Submissions received on Akaroa Wharf Replacement, March 2022

The main wharf in Akaroa has been in operation for around 130 years, and is currently in fairly poor condition. Christchurch City Council (CCC) has proposed that the wharf should be rebuilt, in broadly similar size and location as the existing wharf, and has invited public comment. The comments of ARRA are given below.

Option A, Isthmus, September 6, 2021

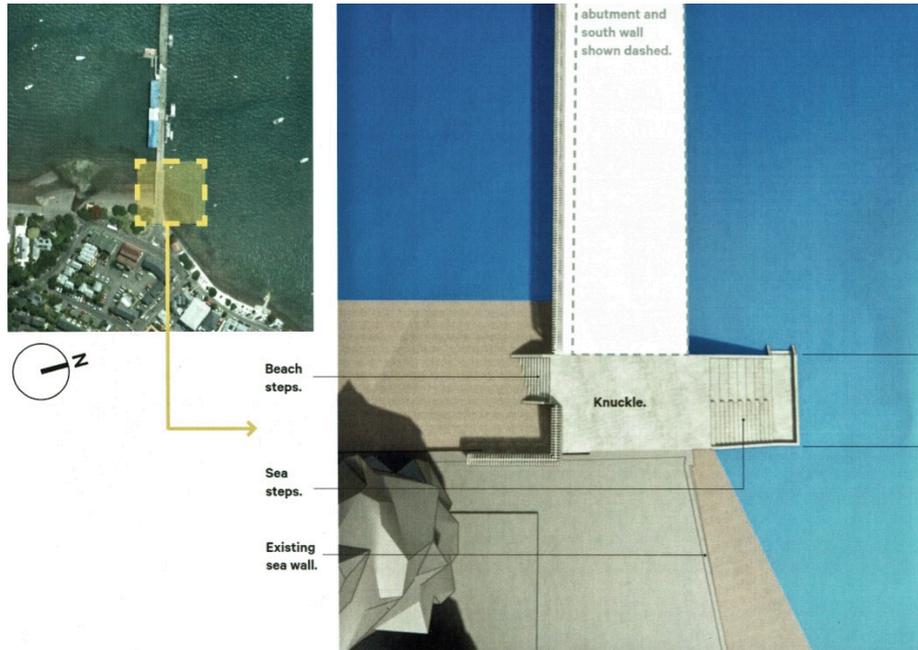
The Civic Trust has reservations regarding the Knuckle design feature (referred to as Option A, below, although no other 'option' has been presented for consideration or discussion).

The start of the wharf is often a location of congestion.

The Knuckle will encourage individuals and children to gather in the vicinity.

In our view, the Knuckle requires an independent assessment with regard to risk and safety issues.

South side of the Akaroa Wharf next to the Britomart Reserve, 2022

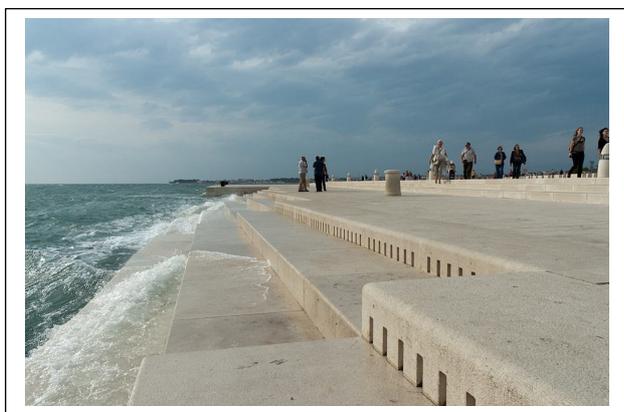
The Knuckle is intended to provide access to the 'beach' and water as an expression of culture associations, however public access to the water is already available in close proximity to the wharf as seen in the image below. (photo: Victoria Andrews)

Location of the Knuckle at the south side of the wharf.

No consideration appears to have been given to sea level rise with regard to the low seawall, Britomart Reserve and access to the shoreline.

- Cultural associations relating to accessing the water can be accommodated via the low seawall area at the Britomart Reserve which does not require steps, modifications or visual intrusions.
- If steps are deemed to be a cultural requirement then decking with steps down to the water's edge can be provided near Fisherman's Rest on the north side of the wharf to avoid congestion and potential conflict between the public and vehicles and equipment used by commercial operators.
